Site Inspection Report

National Green Tribunal (NGT) constituted a committee comprising one member each from Goa Coastal Zone Management Authority (GCZMA); The Ministry of Environment, Forests and Climate Change (MoEF&CC); and The National Institute of Ocean Technology (NIOT) with reference to the "Original application No. 06/2023 (WZ) before the National green Tribunal Western Zone Bench, Pune" to inspect the works being carried out by the Goa State Infrastructure Development Corporation Limited (GSIDCL).

Committee inspected the bridge over the St. Inez creek, walkway cum cycling track, and river coastline protection works being carried out between St. Inez creek and youth hostel along with applicants and representatives of respondent 5 & 7. CRZ maps received from the GCZMA are provided in **Annexure-I**. Photographs taken during the site inspection are provided in **Annexure-II**. During the site visit, applicants provided few supplementary documents related to project and are enclosed in **Annexure-III**.

1: Arch Bridge over St. Inez Creek Showing Pile Caps and Sand Deposition

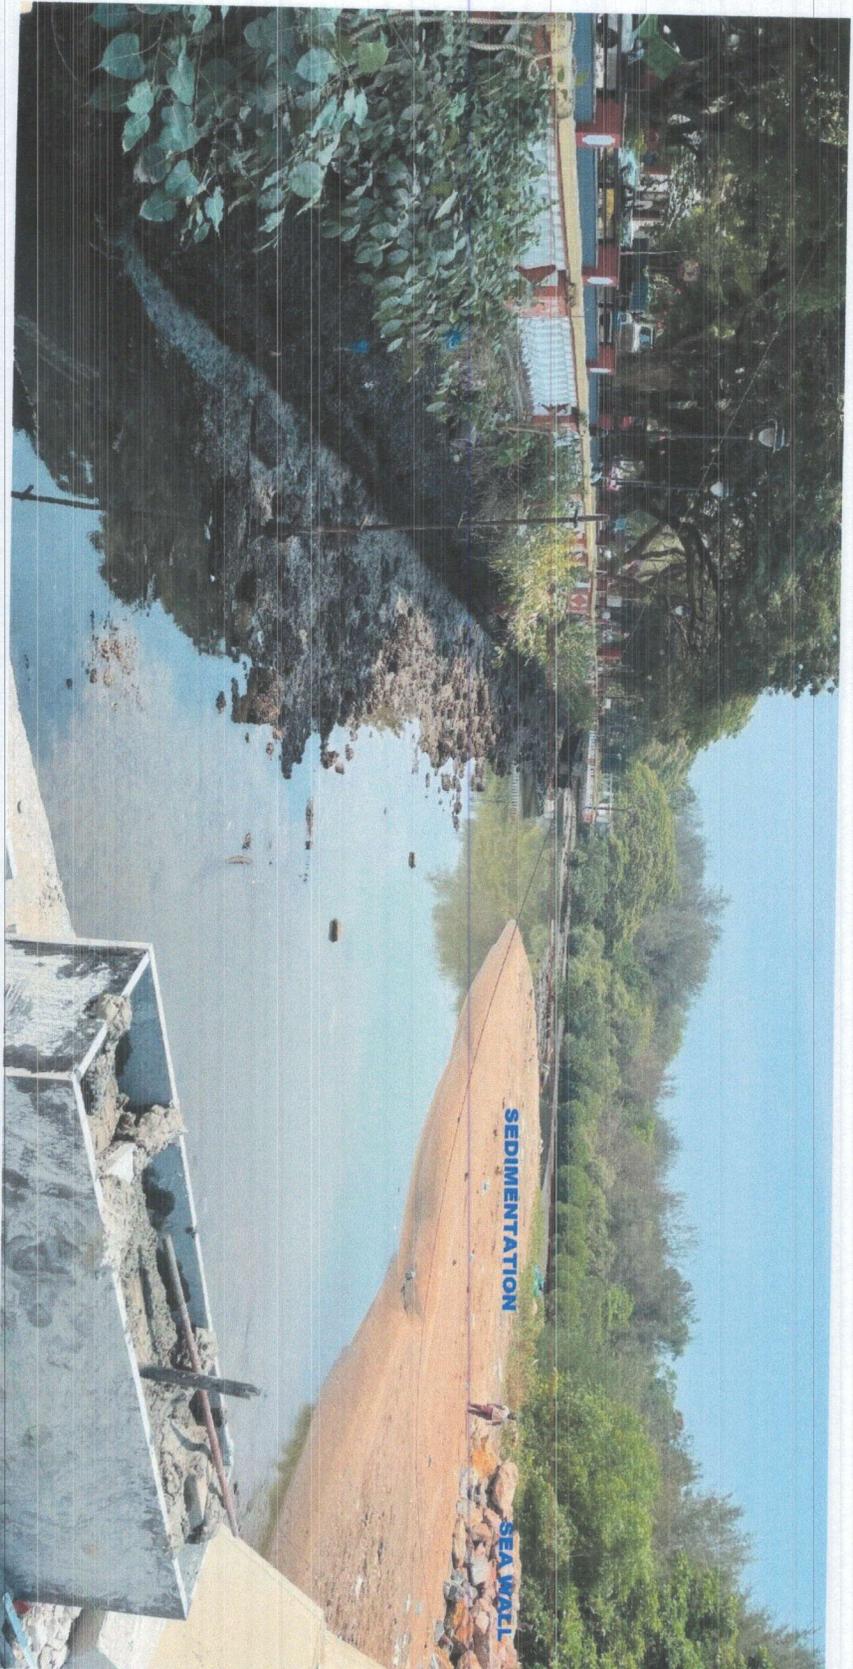
3. Bottom of the western pile cap is resting on river bed and river side of the pile cap was covered with seawall. (*Photograph 1*)
4. GSIDC officials informed that each pile cap was supported by 4 piles of 1.0 m diameter and 33m length. Whereas the CZMP approved drawing shows each pile cap supported by 6 piles but the dimensions of the pile cap and piles are not available.

6. Sand deposition observed beneath the steel bridge and western entrance & rear side of the bridge. (*Photograph 1 and Photograph 2*)
7. Sea wall using granite stones was constructed as river coastline protection measure.

4: Showing Walkway cum Cycling track and Sea Wall, view towards light house

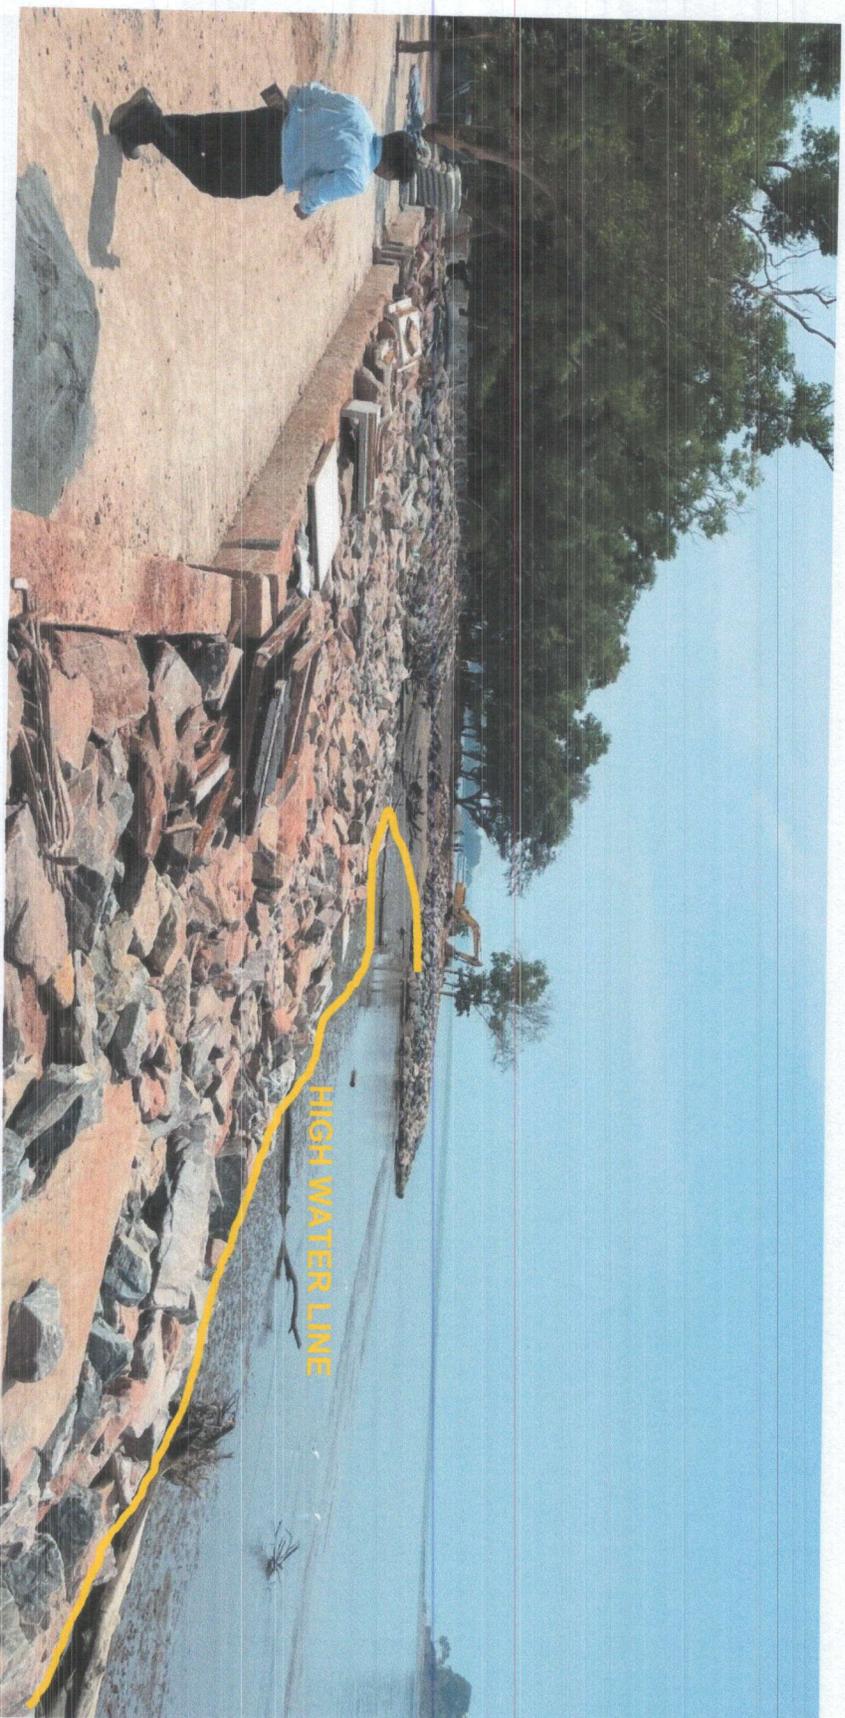
12. Sea wall construction area between Chainage 1+540 and 1+920 is shown as above HTL in the CRZ Map - gv 10006.pdf. whereas high water line marks were observed close to the river bank during the site visit. (Photograph 4, 6 & 7)

5: Construction of seawall between chainage 1+570 and 1+670

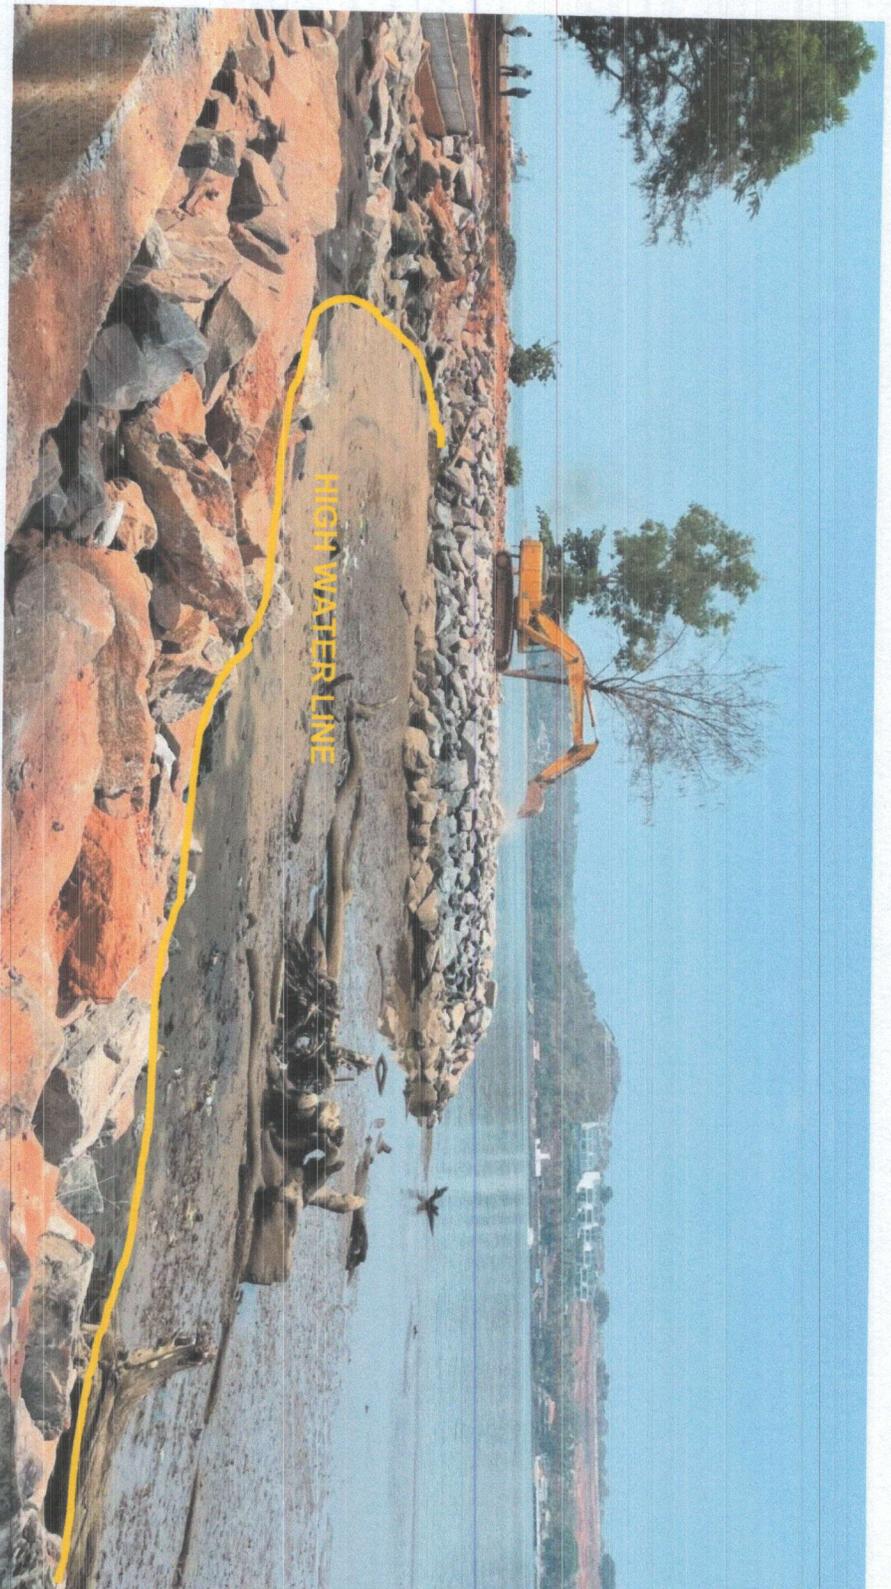
9. EIA report was prepared based on inferences drawn from the earlier study report of CWPRS. Report didn't cover the impact assessment of the river coastline protection measures, impact of the bridge over the St. Inez creek/nallah and the seawall into river constructing between the chainage 1+570 to 1+650.
